Modification Recommended Service Note

N8926A - Autoranging System DC Power Supply, 200V, 140A, 10000W, 208 VAC

Serial Numbers: DE14290000 - DE15369999 without manufacturing ID Version "B"

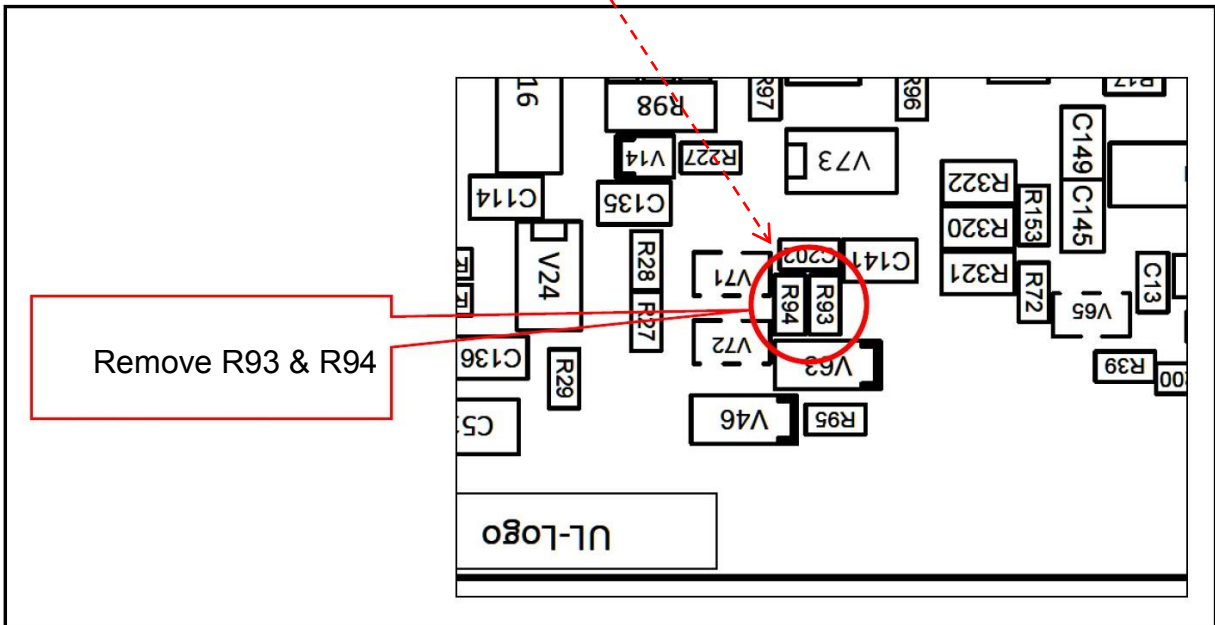
- 1) Remove acMains cable from power source.
- 2) Wait 5 minutes
- 3) Remove top cover from instrument.
- 4) In the 5kW units (viewed from the front of the unit), a small SMT assembly located at the right-rear of instrument will be readily visible (see below):

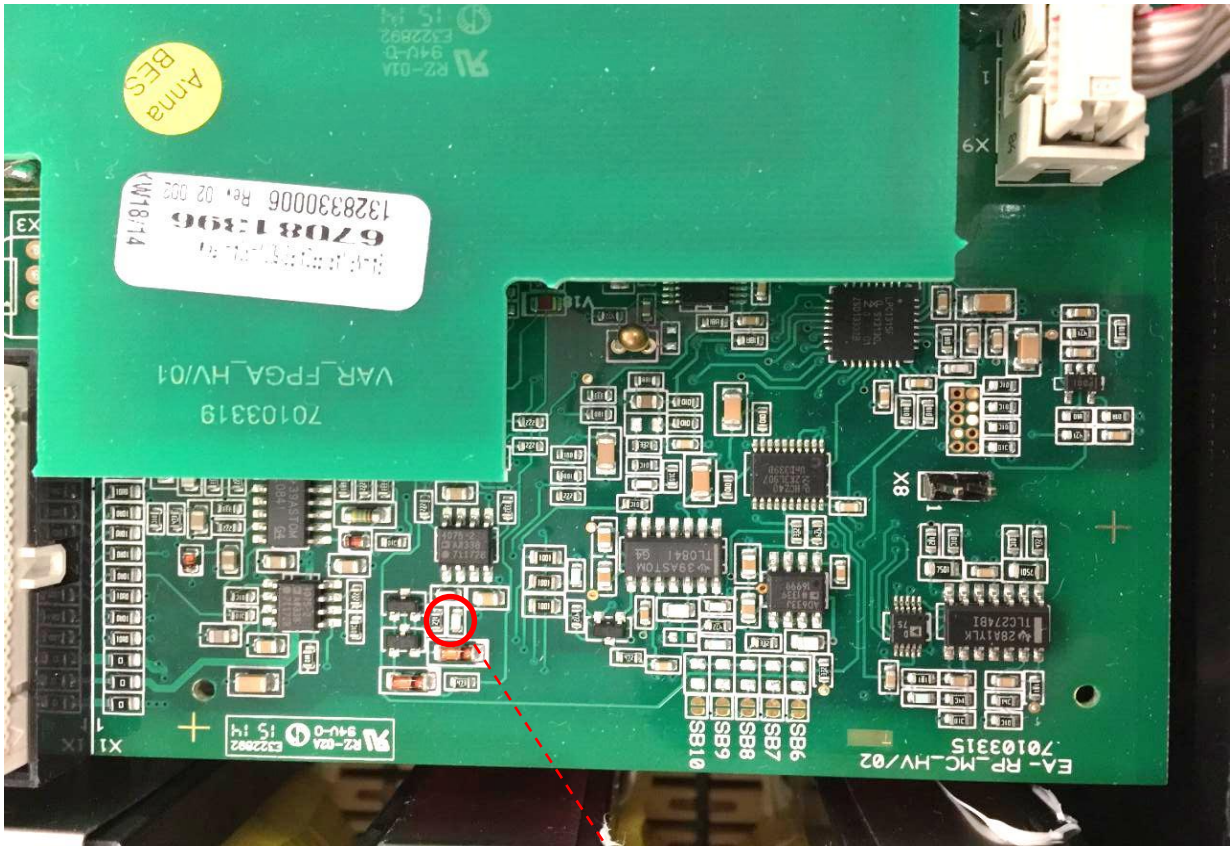
5) SMT resistors R93/R94 are located in red circle shown below:

Removal of two (2) surface mount resistors, R93 and R94, will correct this problem:

6) After removal of R93 & R94, re-install all covers. Instrument does NOT require recalibration after the removal of R93 & R94.

Suffix "B" added

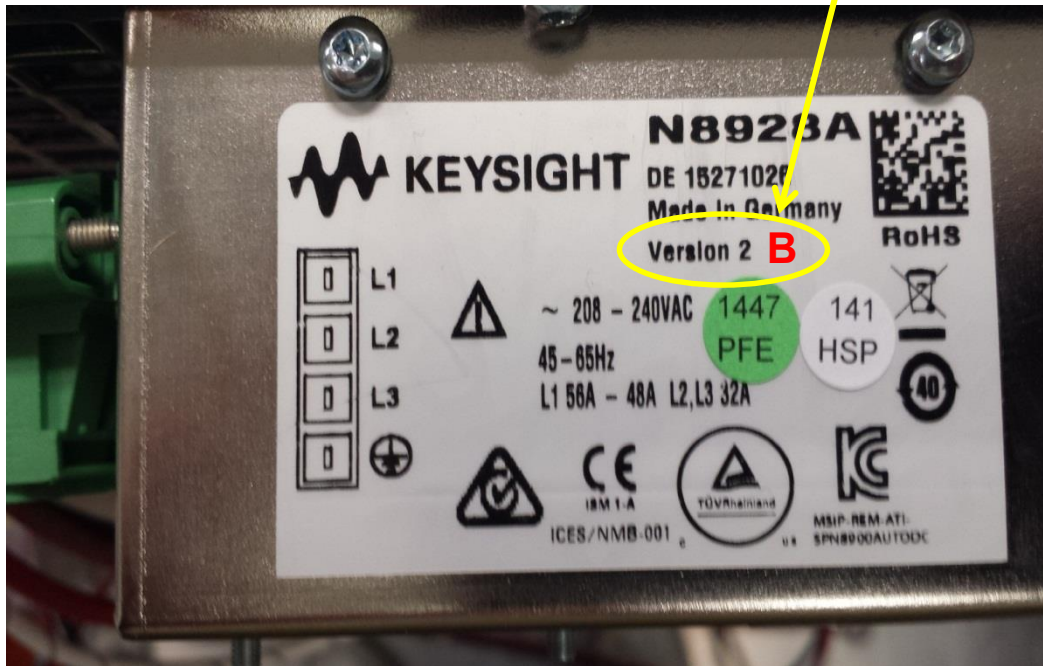
7) On the acMains label, on the rear of the instrument; use an indelible marker, to add the suffix letter "B" after the Version ID. This will assist in the tracking of modified instruments.
